Site Plan Drawing_V1.pdf Markup Summary

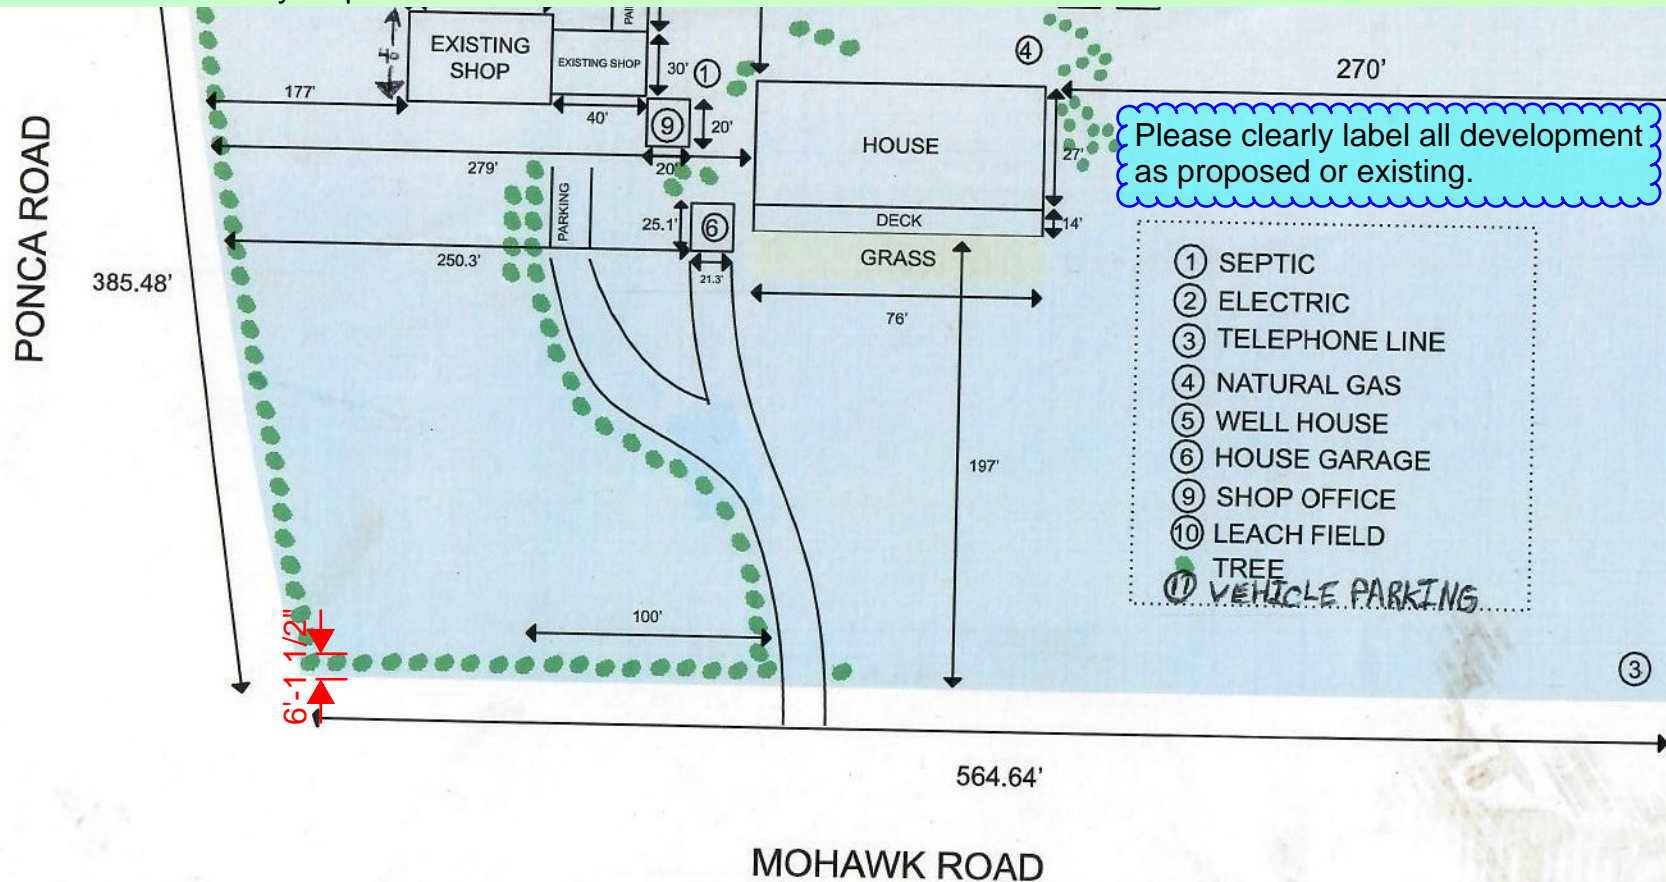
1. This "vehicle parking" area looks like outside storage in an aerial photograph. It looks to be screened with a 6-foot tall, fully-opaque fence or wall as required, but please rename this area as outside storage for vehicles' and note that it is screened per screening requirements for Outdoor Storage in chapter 5.

2. Google Earth's aerial image of property does not show landscaping along outside storage "vehicle parking"; only a fence along the property line is shown, with the landscaping stopping several feet west of the outside storage/vehicle parking area. Please revise plan to reflect what is shown on aerial if applicable.

3. While the number of trees meets the minimum required for road frontage, but the depth of roadway landscaping does not meet the requirement (see measurement of 6' below). If you will not meet the landscape depth requirement, then you may request lesser roadway landscaping depth as part of an Alternative Landscaping Plan request. Please refer to the Roadway Landscaping and Alternative Landscaping Plan sections (sections 6.2.2(A) and (B)) provided via email to castrosbodyshop1@hotmail.com on 12/29.

1. Please add setbacks from all permanent structures to property lines (barn is missing setbacks from eastern property line, for example).

2. Please also add easements as noted on the title commitment and plat. (all side and rear lot lines have 6-foot utility easement per note on the plat.)

3. Please add site data table. Please refer to site plan example and include ALL property and building information shown on that plan, shown directly on the plan or on the data table, as appropriate per the examples. Access the site plan example via this link: <https://assets-planning-development.elpasoco.com/wp-content/uploads/FAQ/SitePlanExampleSmall.jpg>

*Don't forget to include all information on site plan example, including north arrow to indicate north direction.

6'-1 1/2"

Please clearly label all development as proposed or existing.
